AUTOMATIC TRANSMISSION SERVICE GROUP

**REVISED EDITION**

Since the introduction of the THM 440-T4 Transaxle in April, 1984, there have been many major engineering design changes. These changes have affected nearly every part used in the THM 440-T4. This Update Handbook will explain each change, the parts affected by the change, and any parts interchangeability problems created by the change.

Figure 5

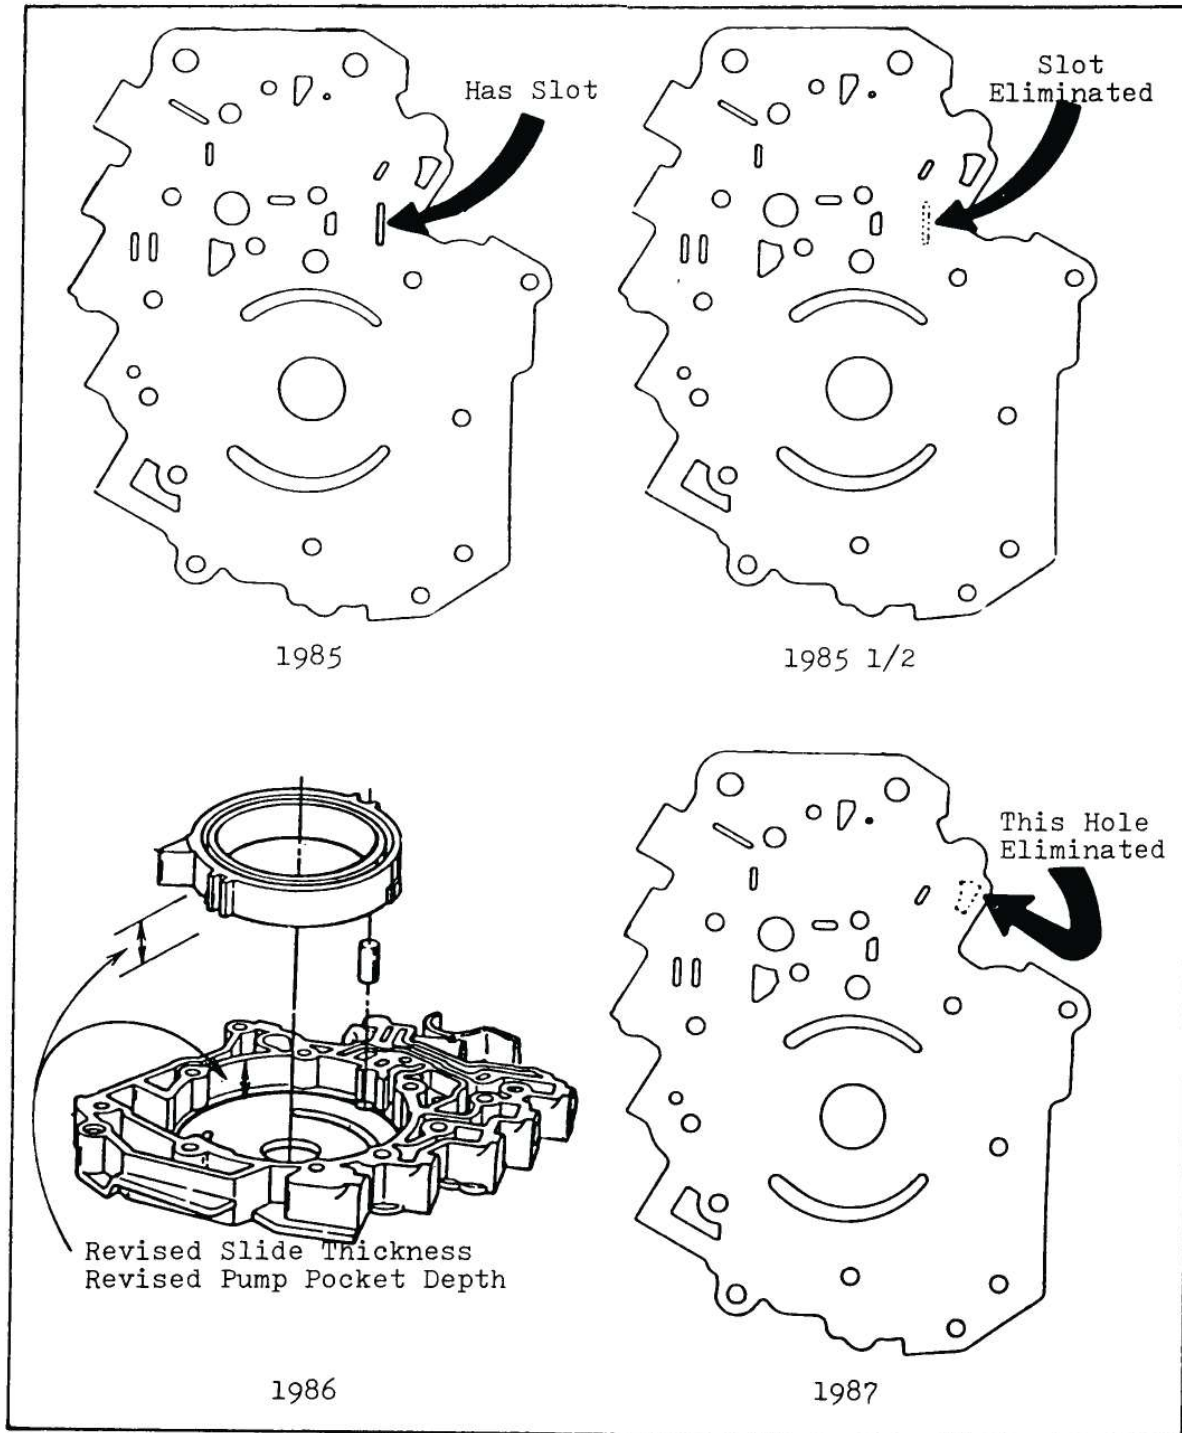
1985	Identification:	Has slot in pump body (See Figure 5).
	Interchangeability:	The 1985 pump body will not work on 1985 1/2 up valve body unless spacer plate is used to eliminate slot. If used without the spacer plate result will be tie-up when transaxle shifts to 4th gear.
1985 1/2	Identification:	Slot in pump body was eliminated (See Figure 5).
	Reason:	Addition of 3-2 TV bias valve in valve body and complete revision of hydraulic circuit for improved 3-2 downshift.
	Interchangeability:	Will interchange on 85 1/2 and 1986 models only.
1986	Identification:	No way to identify from 1985 1/2. Pump pocket depth was made shallower by .001" which created 5 new slide sizes unique to the 1986 pump. See chart on page 6.
	Reason:	Improved pump capacity.
	Interchangeability:	Will interchange with 85 1/2 only, as long as proper slide selection is made to correspond with depth of pump pocket.
1987	Identification:	Hole eliminated in pump body (See Fig. 5).

Reason:	Improved 3-2 downshift. Modulator oil was fed thru the hole in pump body to stroke the 3-2 coastdown valve. Improved 3-2 downshift could be obtained by using servo release oil to stroke the valve, so hole was eliminated and the 3-2 maneuver pipe was added to carry servo release oil to the 3-2 coastdown valve in pump body (See Figure 6). This also made a change in the pump cover necessary with an additional hole and seal to accept the 3-2 maneuver pipe.
	Interchangeability:	Will retro fit back to 85 1/2, and is recommended. The 3-2 maneuver pipe must be used with it. Not interchangeable unless 3-2 maneuver pipe is used.

Figure 7

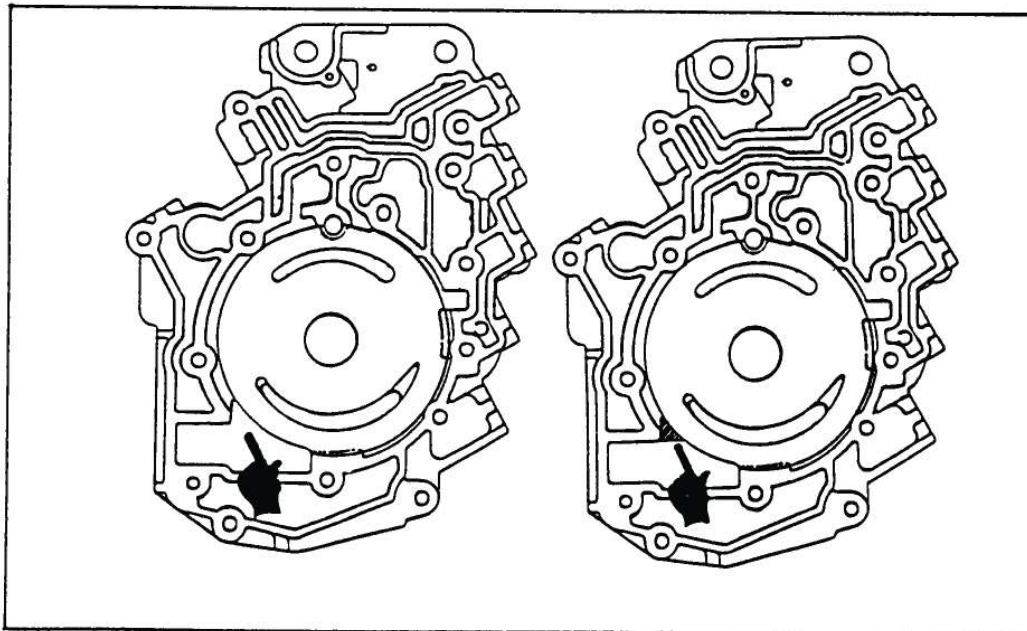
If flash is present you will have to replace the oil pump assembly, or use a Dremel Tool with a carbide bit and remove flash from 87 model to match contour of 86 model (See Figure 7).

Figure 8

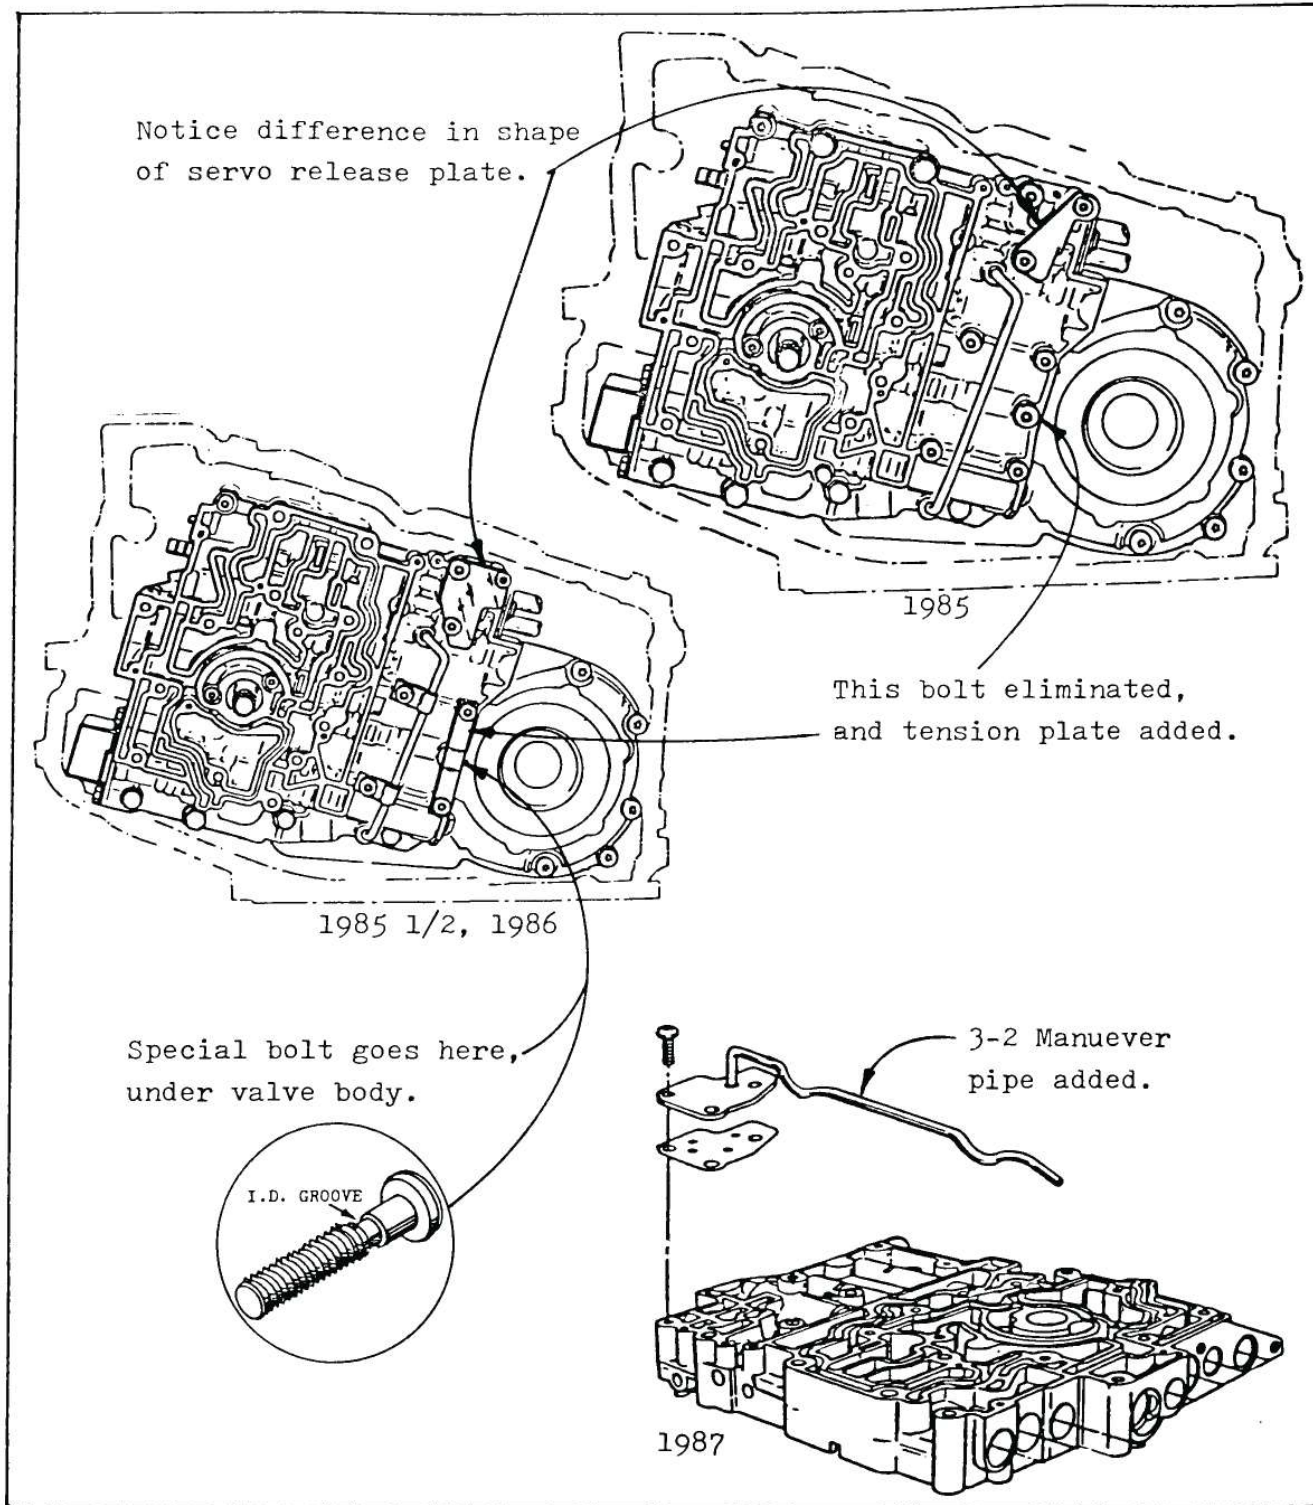
1985	Identification:	Notice difference in shape of 1-2 servo release plate. Also extra bolt in valve body (See Figure 8).
	Interchangeability:	NOT INTERCHANGEABLE.
85 1/2, 86	Identification:	Notice difference in shape of 1-2 servo release plate (See Figure 8). Extra bolt eliminated in valve body to make room for the addition of 3-2 TV bias valve in valve body (See Fig. 9). Special bolt added under valve body in channel plate, and addition of tension plate (See Figure 8).
	Reason:	Improved 3-2 downshift.
	Interchangeability:	Not Compatible with 1985. Will interchange with 86 models, as long as calibration requirements are met.
1987	Identification:	Addition of 3-2 maneuver pipe (See Figure 8).
	Reason:	Further improved 3-2 downshift.
	Interchangeability:	Not compatible with 1985. Will interchange with 85 1/2 and 86 models, as long as calibration requirements are met.

Figure 16

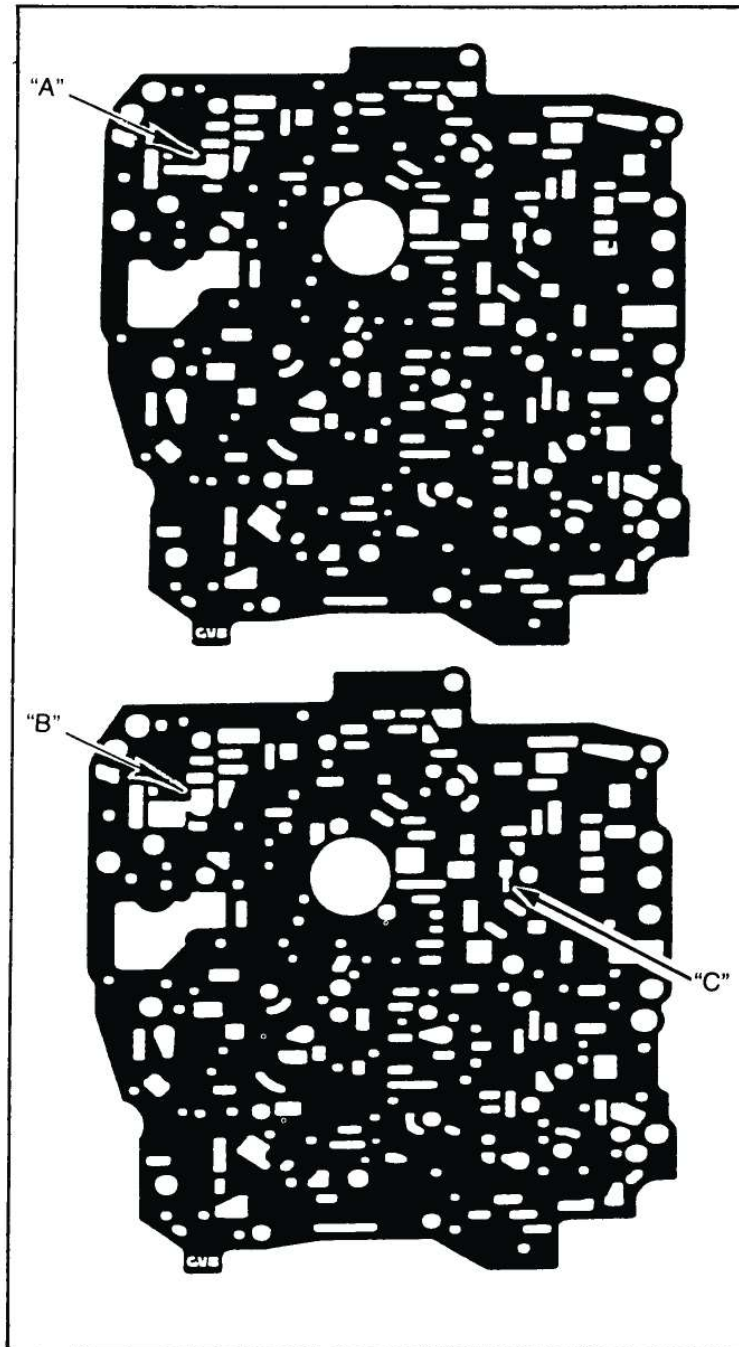
Note the difference in the "Pipe Stem" between "A" and "B", Figure 16. This change occurred about Oct. 1985.

In June 1987 the "Finger" shown at "C", Figure 16 was made Approx. .020 wider.

Figure 17 (1985 Only)

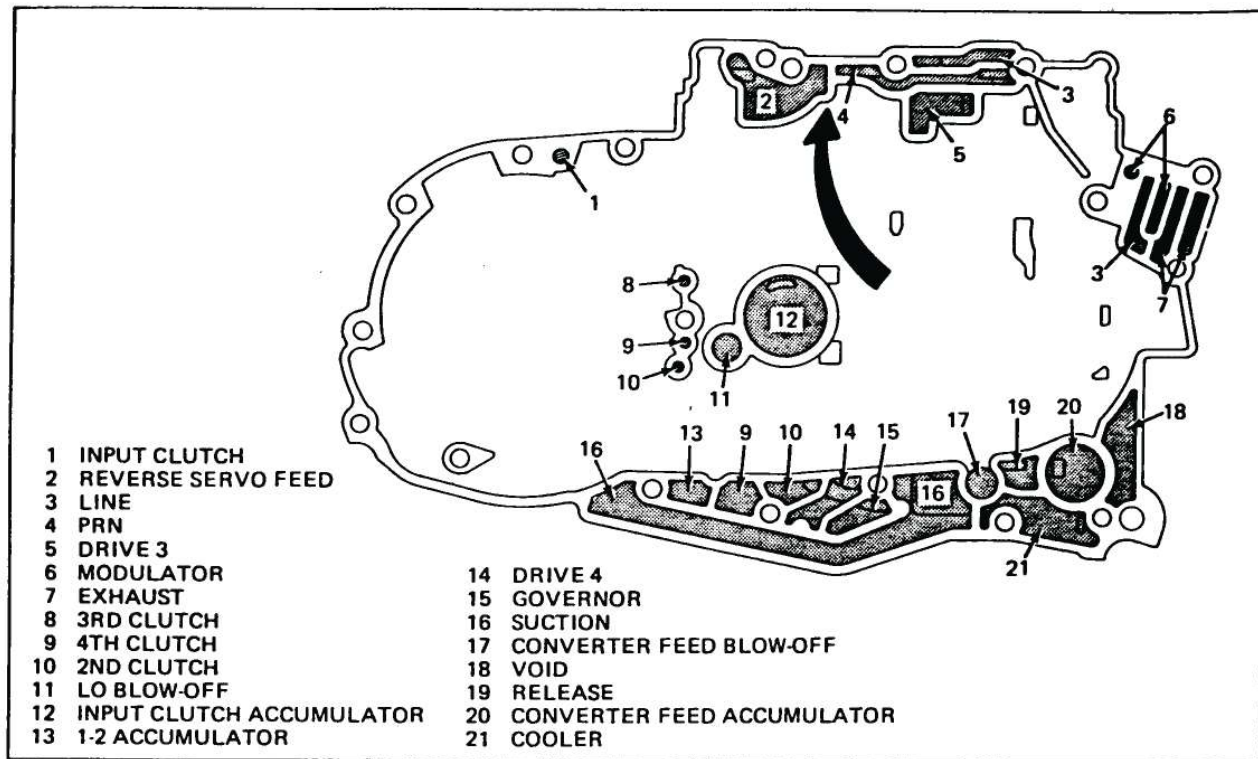
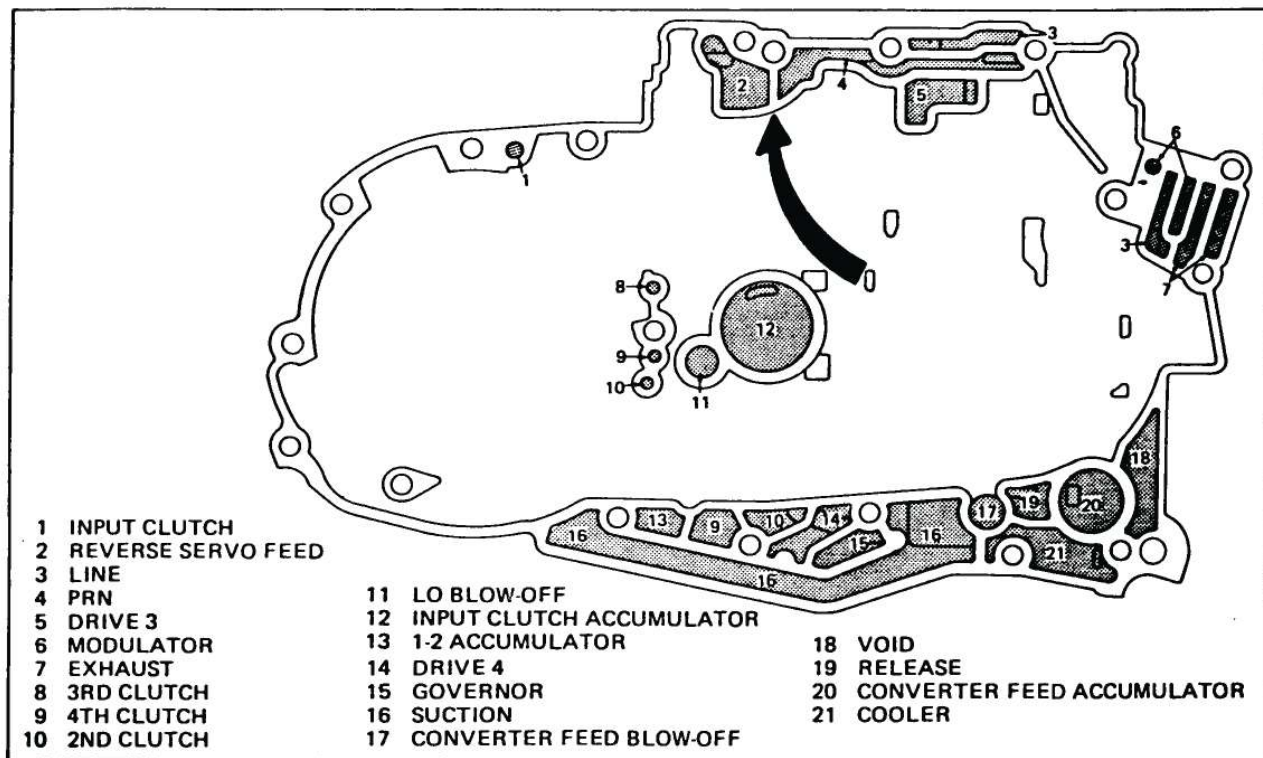
- 1985**
- Identification:** The easiest way to identify the channel plates apart is the location of the dam in the upper channel plate worm track area. (See Figure 17 and Figure 18). The dam was moved to an area directly under the upper dowel pin bore.
- Reason:** Complete change in hydraulic system for improved 3-2 downshift.
- Interchangeability:** 1985 will work with 85 hydraulics only. CANNOT MIX PUMP, VALVE BODY, OR CHANNEL PLATE.
- 1985 1/2, 1986, and 1987 will interchange as long as calibration requirements are met.

Figure 21

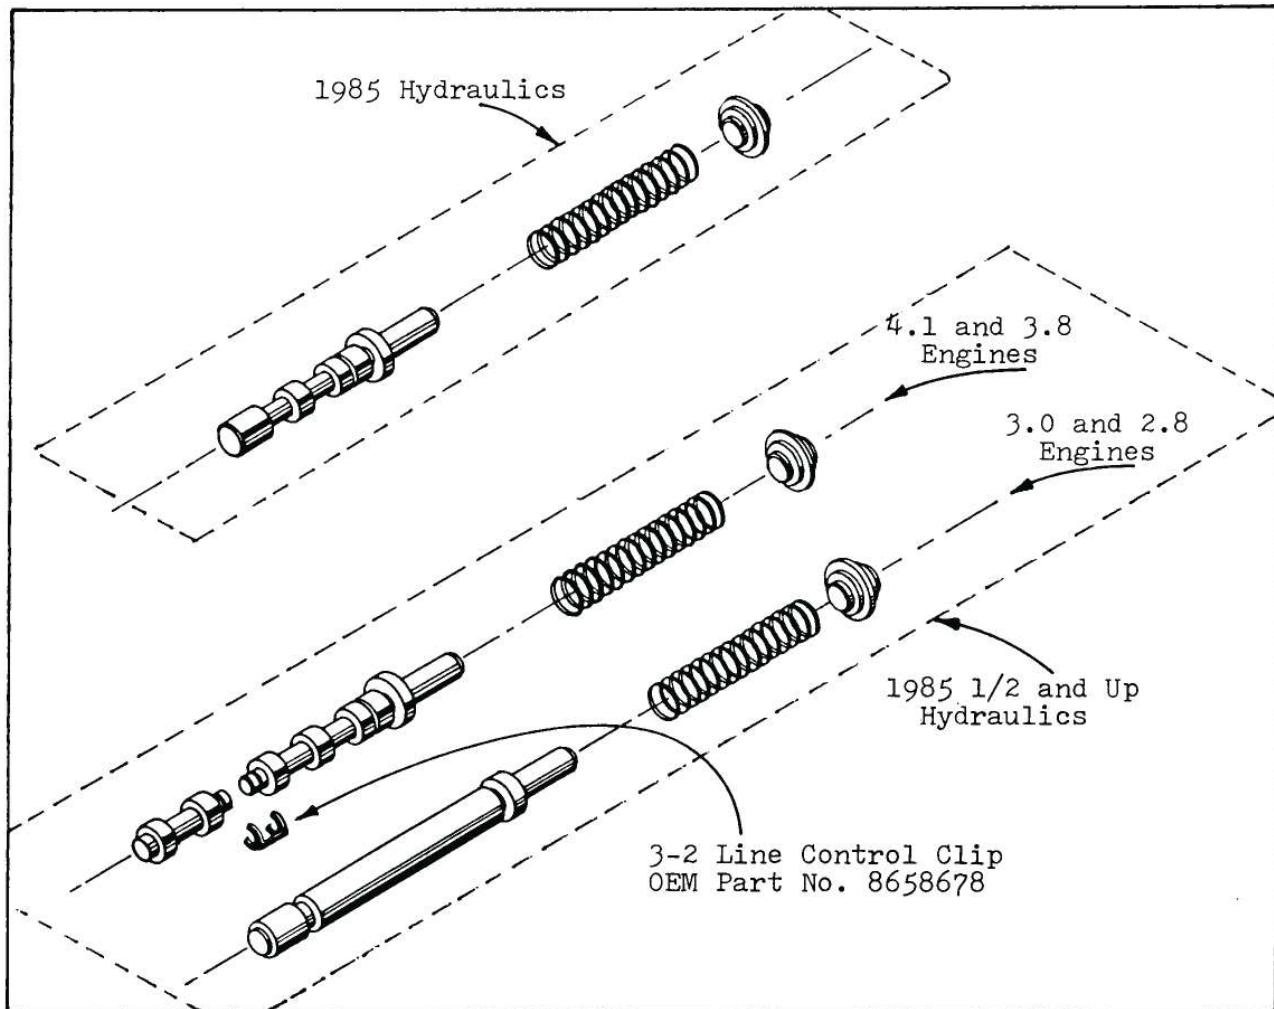
- 2) The 3-2 line control valve located in the channel plate (See Figure 20 For Location), was changed from a single valve, to a two piece valve (See Figure 21). The 2 piece is connected together with a small clip that has a bad habit of breaking, and will create no 3-2 downshift.

Also notice (See Figure 21) that there are 2 line ups for the 85 1/2 and up models. The 2 piece 3-2 line control valve is used on 4.1 Cadillac, and 3.8 Buick engines. The "Plug" that is also shown (Figure 21), is used on 3.0 Buick, and 2.8 Chevrolet engines.

Figure 22

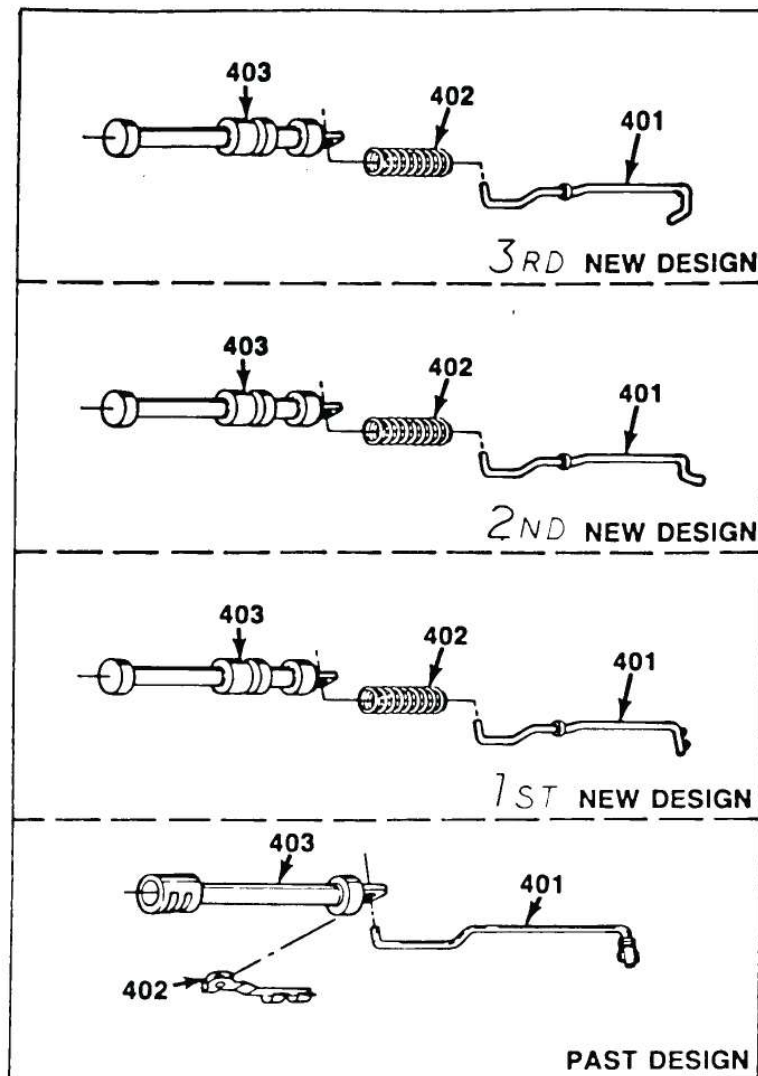
- 3) There has also been some re-design of the manual valve, retainer clip, and manual link to assist in the assembly process (See Figure 22).
